VILLAGE OF ROYAL PALM BEACH, FLORIDA

PROJECT NAME: COMMONS PARK PATHWAY LIGHTING  
PROJECT NUMBER: PR1903

**ADDENDUM NUMBER: FIVE**

DATE OF ISSUANCE: September 28, 2021

DATE: AUGUST 2021  
SHEET: E-7 OF 25

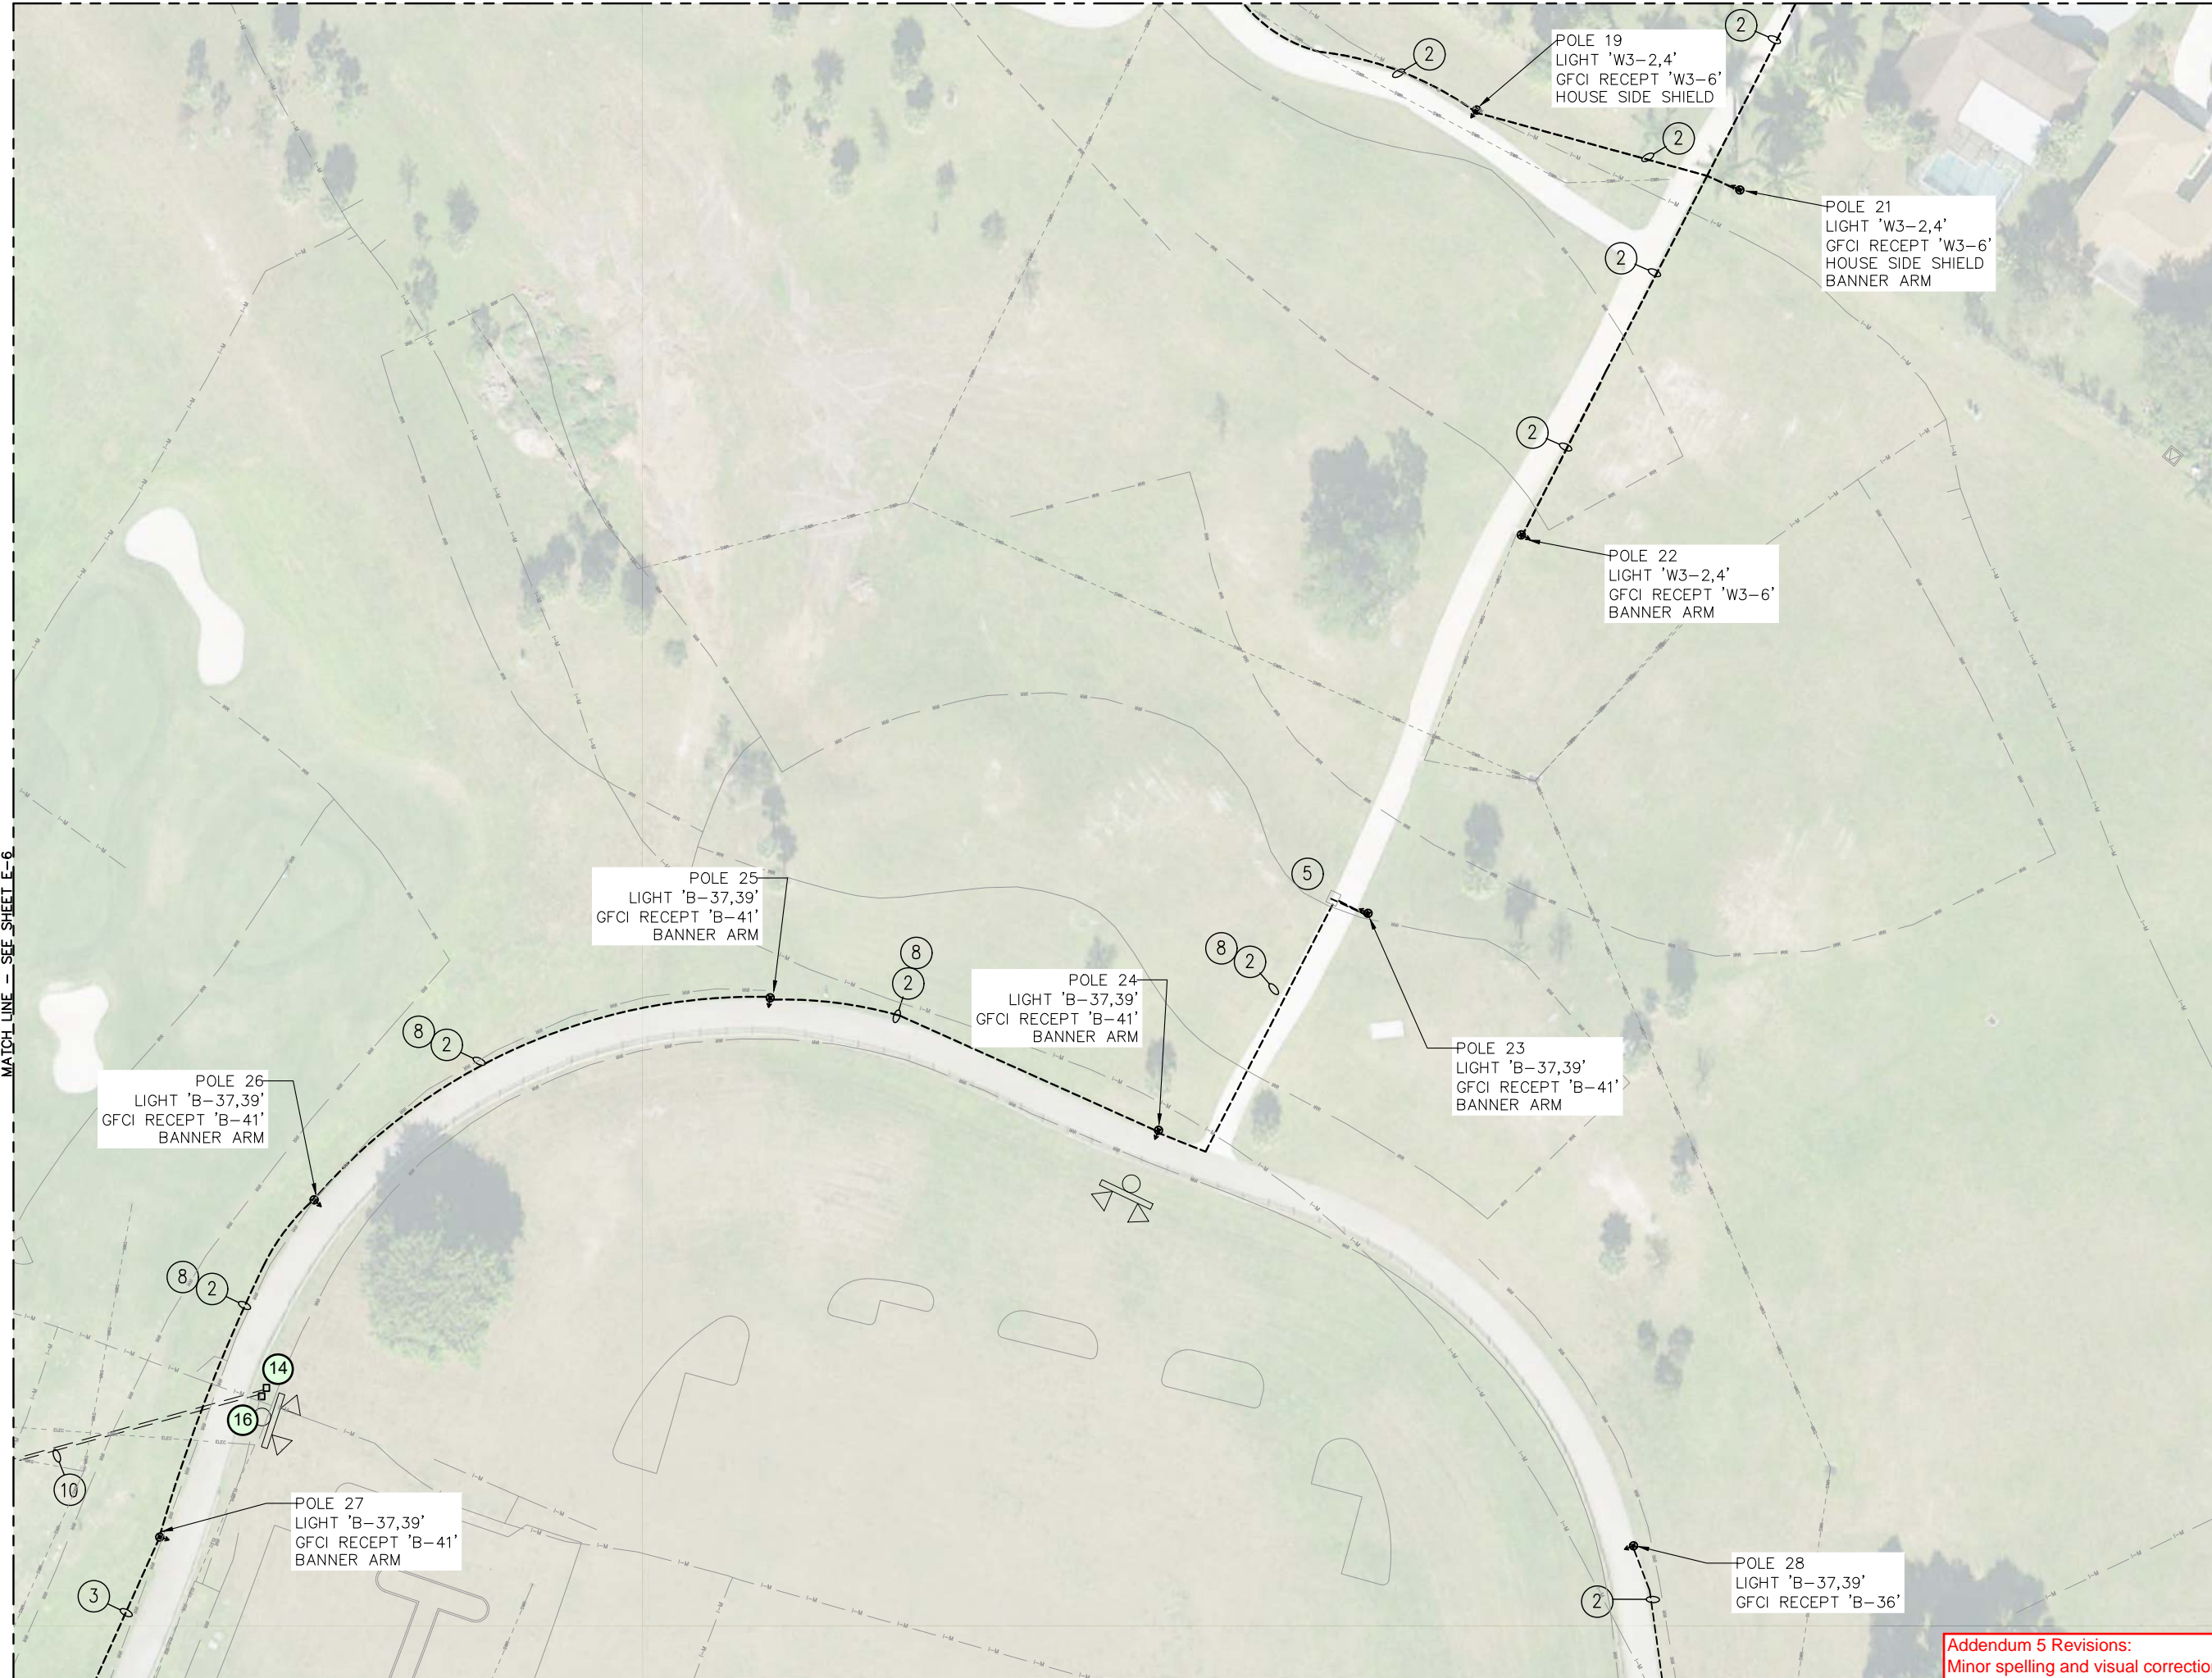
Addendum 5 Revisions:  
Minor spelling and visual corrections; Key Note 5 updated; Key Notes 14-17 added; Added Symbol Legend; Intermediate pull boxes in the middle of each run between proposed poles have been removed.

DATE: AUGUST 2021  
SHEET: E-8 OF 25

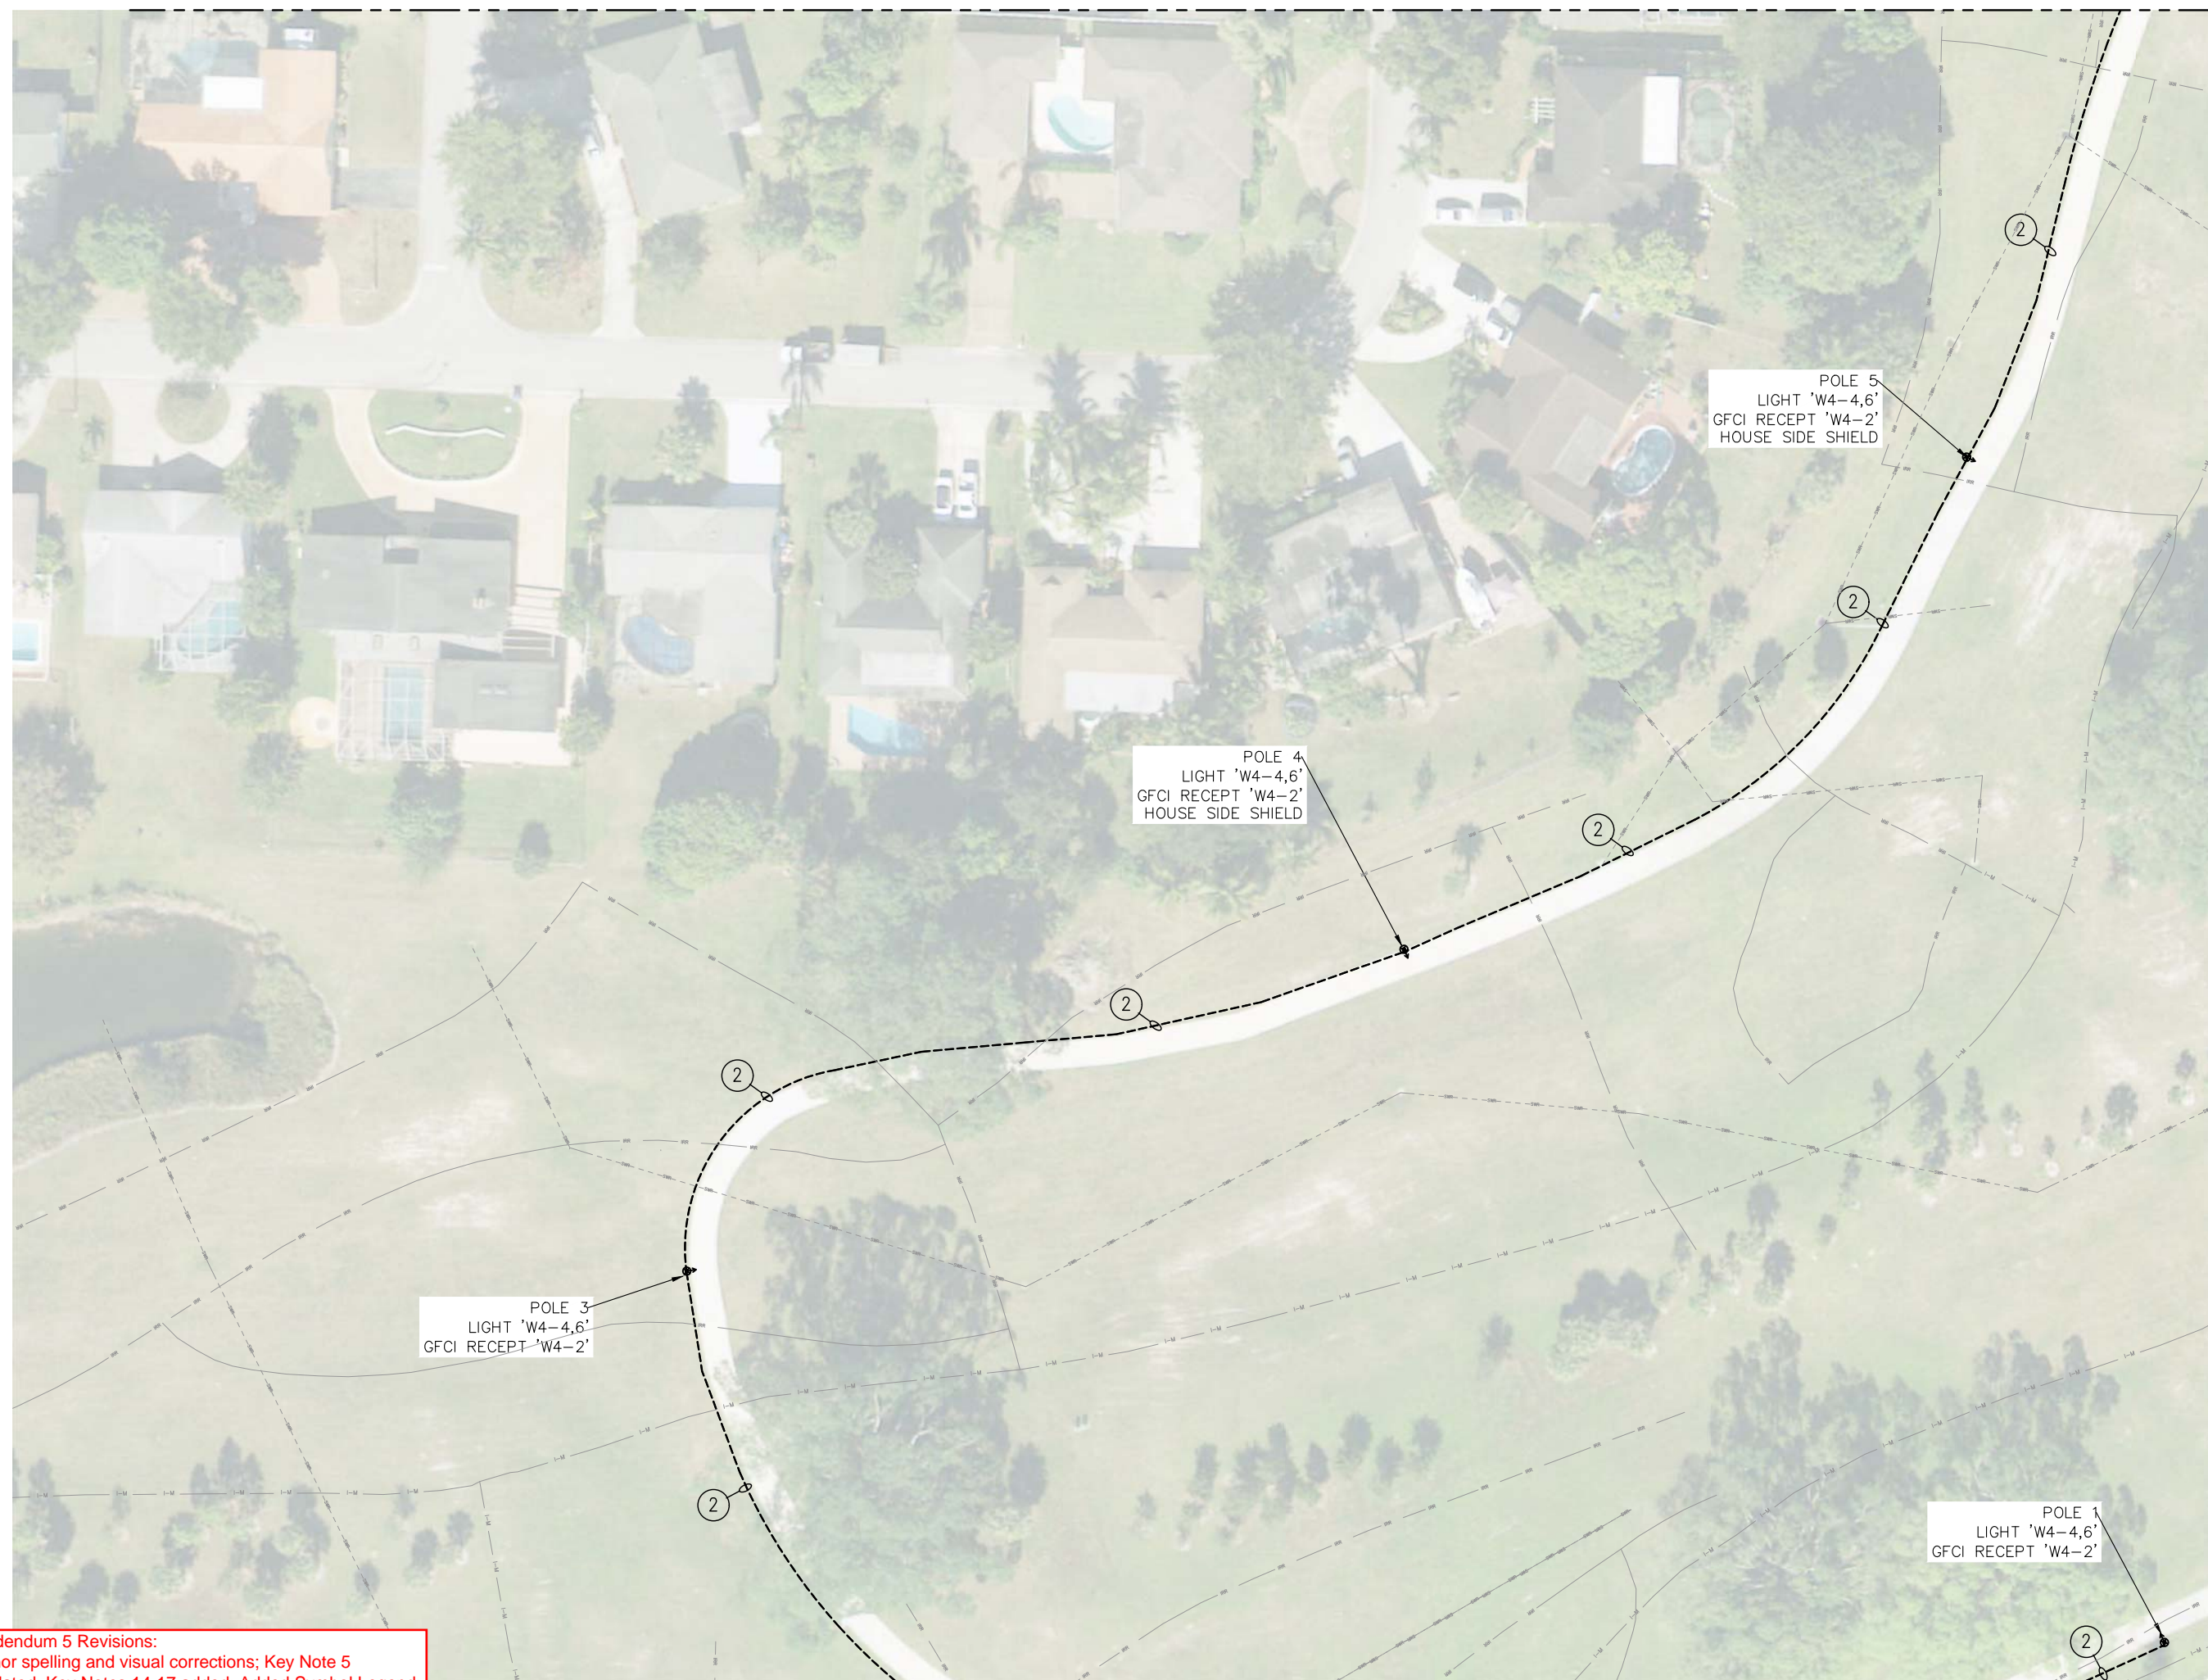
Addendum 5 Revisions:  
Minor spelling and visual corrections; Key Note 5 updated; Key Notes 14-17 added; Added Symbol Legend; Intermediate pull boxes in the middle of each run between proposed poles have been removed.

DATE: AUGUST 2021  
SHEET: E-10 OF 25

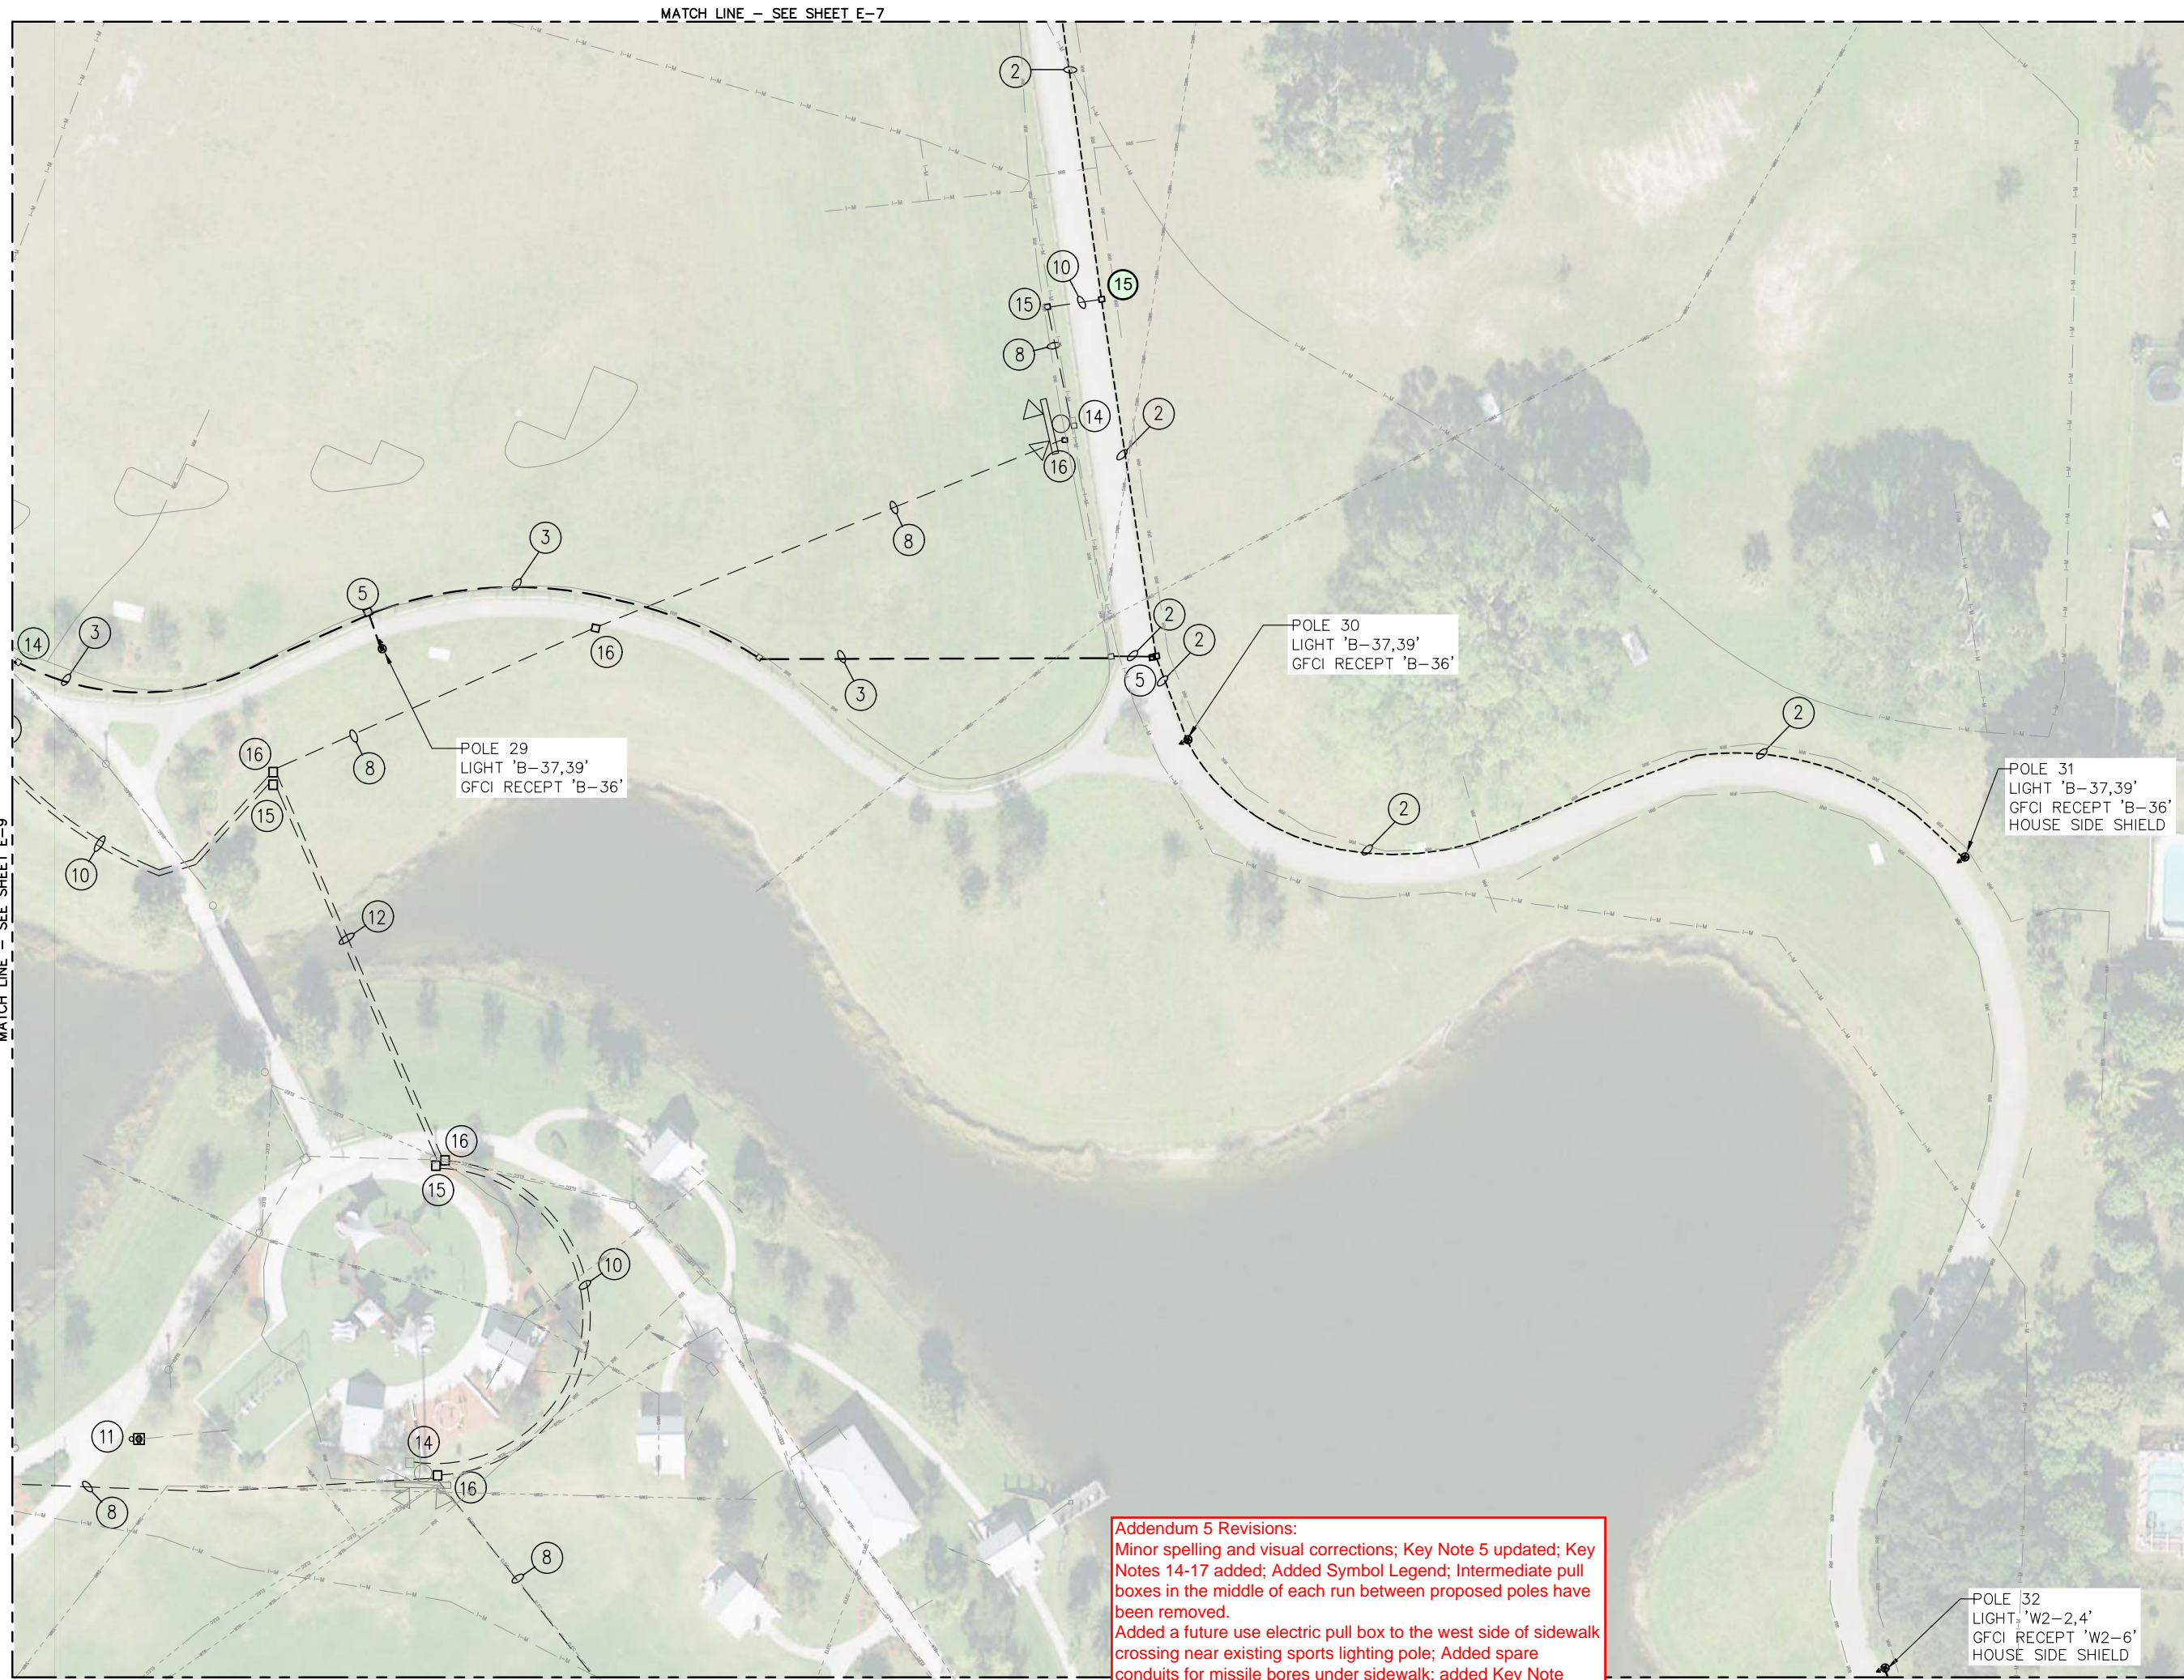
**Addendum 5 Revisions:**  
 Minor spelling and visual corrections; Key Note 5 updated; Key Notes 14-17 added; Added Symbol Legend; Intermediate pull boxes in the middle of each run between proposed poles have been removed.  
 Added a future use electric pull box to the west side of sidewalk crossing near existing sports lighting pole; Added spare conduits for missile bores under sidewalk; added Key Note designation for directional bore under canal. Future use fiber and electric conduit and pull boxes have been separated.
